DEVELOPMENT APPLICATION ASSESSMENT REPORT

Application Number:	DA2023/0133
----------------------------	-------------

Responsible Officer:	Jordan Howard
Land to be developed (Address):	Lot 1 DP 18022, 54 Abbott Road NORTH CURL CURL NSW 2099
Proposed Development:	Alterations and additions to an approved dwelling house
Zoning:	Warringah LEP2011 - Land zoned R2 Low Density Residential
Development Permissible:	Yes
Existing Use Rights:	No
Consent Authority:	Northern Beaches Council
Land and Environment Court Action:	No
Owner:	Timothy James Dodd
Applicant:	Timothy James Dodd

(Figure 1 - Western Elevation with Side Boundary Envelope Encroachment in Red)

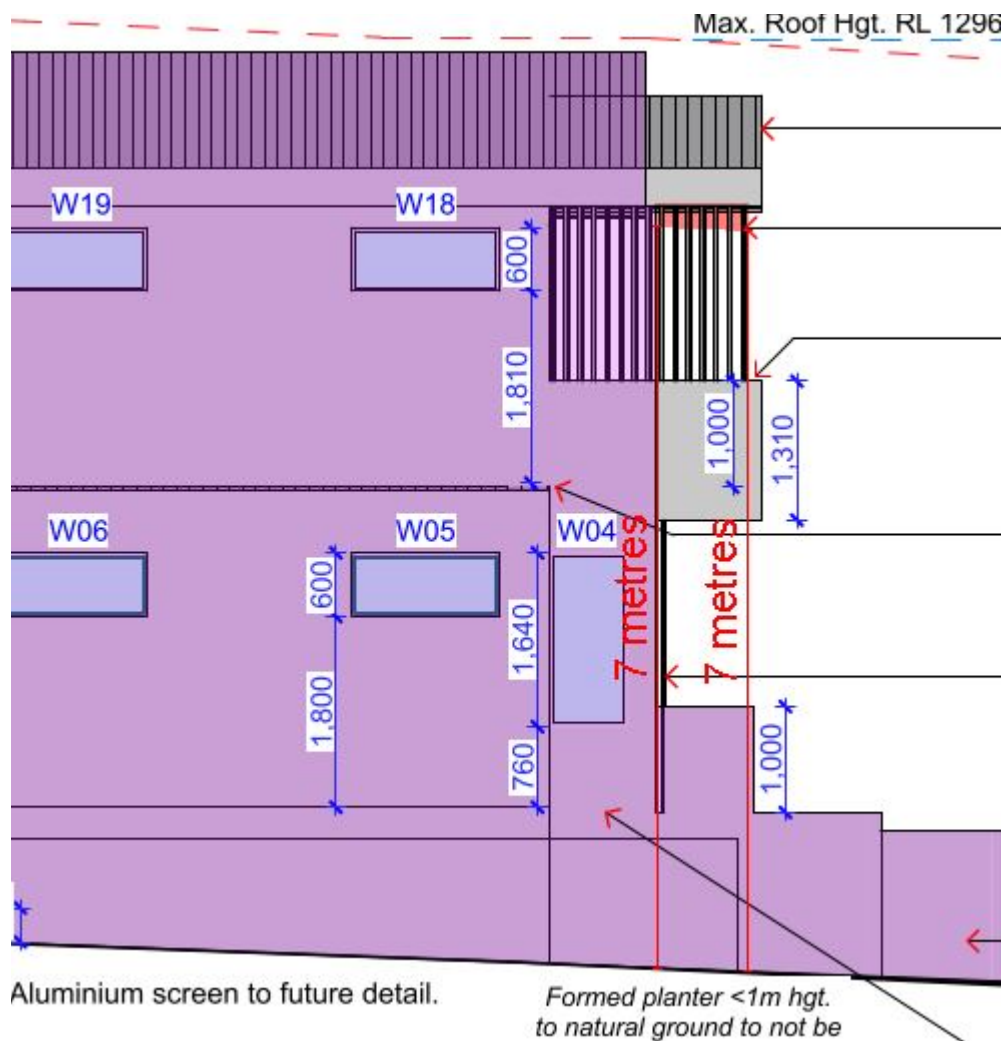
Under this clause, buildings must be sited within a building envelope determined by projecting planes at 45 degrees from a height of 5m above ground level (existing) at the side boundaries.

The proposed development encroaches the side building envelope on the western elevation as depicted in *Figure 1*. The encroachment measures 0.9m in horizontal length and a maximum of 0.2m in vertical length, representing a 2.9% variation to the control. The encroachment is limited to the extended privacy screen on the east of the extended southern elevation balcony.

The proposal is compliant with the maximum height of buildings development standard, wall height control, and side boundary setbacks control. The breach is minor in nature and limited to an extended privacy screen, not a solid wall. The proposal is not considered to be visually dominant by virtue of its height and bulk.

The proposal provides adequate setback from the site boundaries and is considered to provide adequate spatial separation between buildings to maintain a reasonable level of light, solar access and privacy. Notably, the breach is limited to an extended privacy screen which

Having regard to the above assessment, it is concluded that the proposed development is consistent with the relevant objectives of WDCP and the objectives specified in s1.3 of the Environmental Planning and Assessment Act, 1979. Accordingly, this assessment finds that the proposal is supported, in this particular circumstance.
